ANNEX C

SNODLAND CHARACTER AREA APPRAISAL SPD – RESPONSE TO CONSULTATION

APPENDIX C1

Ref **A2.1**
 Title **Holborough Road**
 Snodland Character Area Appraisal

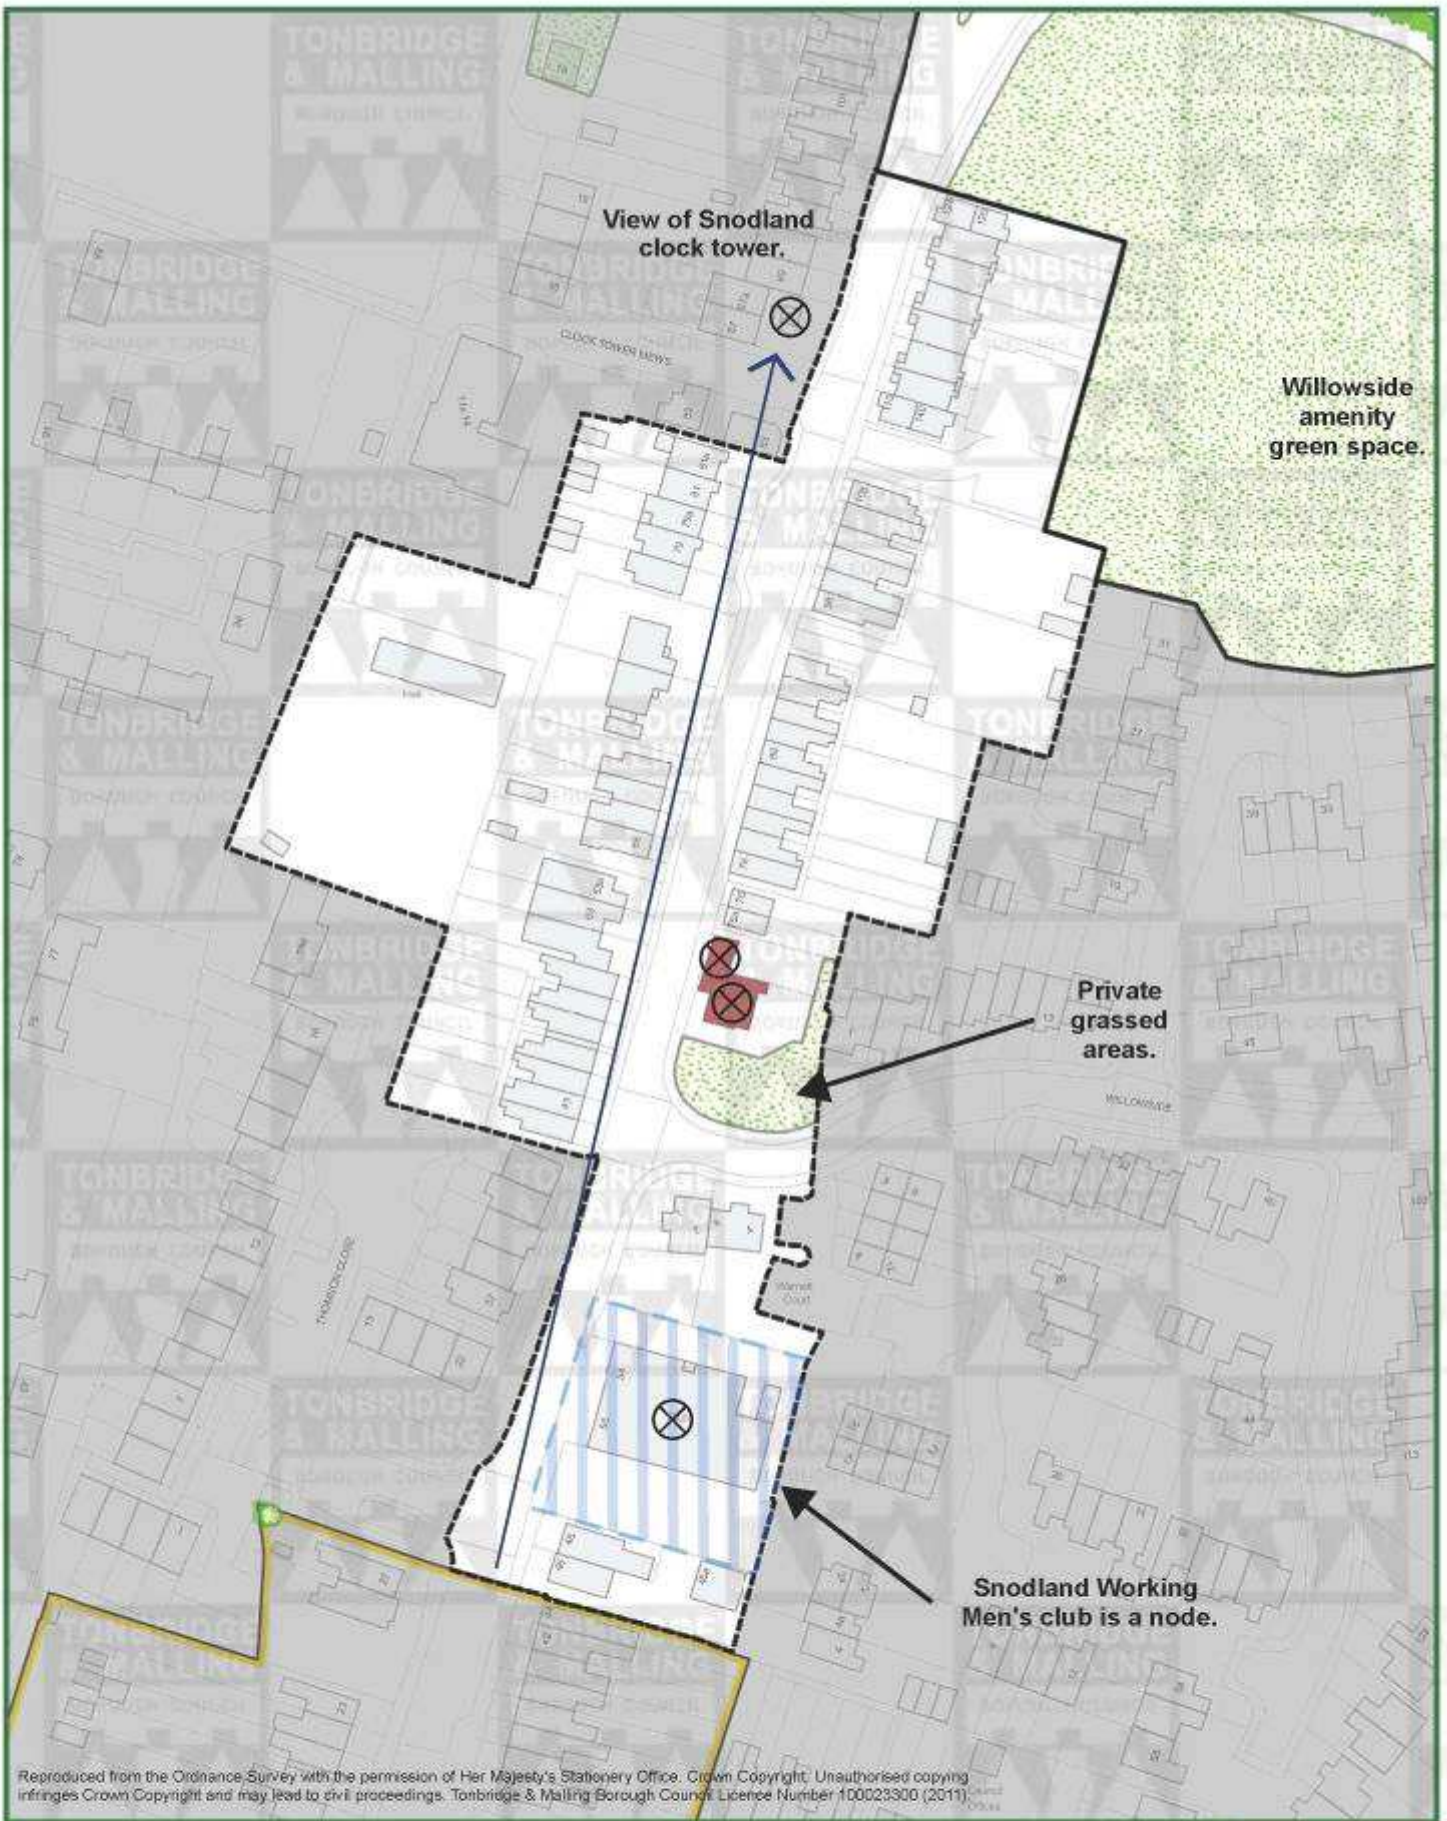
Respondent	Representation	Response
	<p>Area A2.1 – Holborough Road –Description (p37)- The photographs do not extend to the northern end of Holborough Road so a significant length of the main road is not covered.</p>	<p>REVISE to deal with the northern section of the road as a separate sub- area. (See Appendix C1)</p>
	<p>Area A2.1 – Holborough Road – Description (p37) - The northern end of Holborough Road should be a separate sub-area. The text under the middle photograph states that there is now little uniformity of detail in Holborough Road. Do not agree:</p> <ul style="list-style-type: none"> • There are distinctive short terraces of 19th century houses with narrow arched windows in groups of three with arched dormers which are not mentioned; • There is no mention of old yellow stock bricks with red brick banding and features to window lintels and doorways, terracotta patterned brick bands and the old traditional ragstone wall frontage; • Most houses at the northern end of the road are in brick and not painted render as currently described • The outlook onto open space is also important. 	<p>See above.</p>

<p>Area A2.1 – Holborough Road – Contextual Features (p41):</p> <ul style="list-style-type: none"> • Type of buildings – needs to include detached. There are 	<p>See above.</p>

Respondent	Representation	Response
	<p>quite a few detached buildings;</p> <ul style="list-style-type: none"> • Building heights – there are no 3 storey buildings; • Prominent building materials – yellow stock brick not brown brick; • Open Spaces – needs to refer to the grassed amenity areas at the road junction and adjacent to the bypass and to the rear of properties. 	
	<p>Area A2.1 – Holborough Road – Extent of area (p42) – The “Natural Green Space” to the rear of properties in Holborough Road should be included in Area A2.1 rather than Area I5 (Holborough Lakes) because it most affects these properties and is part of this linear development.</p>	<p>Technically, this strip of land is part of the Holborough Lakes development. It is only visible from the rear of the houses on Holborough Road (not from the public realm), but will be visible from the roads and pathways of Holborough Lakes. It is appreciated that this land is important to the northern part of Holborough Road, but it does not form part of its character and therefore is referred to, but not included within the area.</p>

<p>Area A2.1 – Holborough Road – Positive Features (p41):</p> <p>Need to include:</p> <ul style="list-style-type: none"> • Views over open space to the tree line along the bypass; • No through traffic because it is a cul-de-sac; • Quiet despite proximity of major road; • 19th century cottages add interest to road frontage. 	<p>The new sub-area for Holborough Road North addresses these issues – see Appendix C1</p>

Respondent	Representation	Response
	<p>Area A2.1 – Holborough Road – Negative Features (p41)</p> <p>The brick wall at the far northern end of road should be removed and replaced by a hedge/trees along the edge of the bypass.</p>	<p>Noted as a negative feature worthy of enhancement in Appendix C1</p>
<p>Vincent and Gorbing Ltd on behalf of Lafarge Cement UK</p>	<p>The document is very attractive and thorough which is a good appraisal of the character of Snodland subject to the following detailed minor points.</p>	<p>Noted</p>
	<p>There is some inconsistency in the reference to brick colours where in some cases what appear to be the same colour bricks are described in different places as yellow, orange, buff or brown.</p>	<p>This will be checked carefully and any inconsistencies addressed.</p>
	<p>Map 2 – label for Area B3 is incorrectly located within Area E7.</p>	<p>CORRECT Map 2</p>
	<p>Map 3 - some of the periods on the plan do not correspond with the notes for the individual Character Areas. For example, Area E9 is shown as 1980s on the map but correctly described as 1970s in the Appraisal. Also should Holmesdale School be shown as 1980s when it was originally built in the 1930s/50s?</p>	<p>This will be checked carefully. CORRECT Map 3 as necessary.</p>
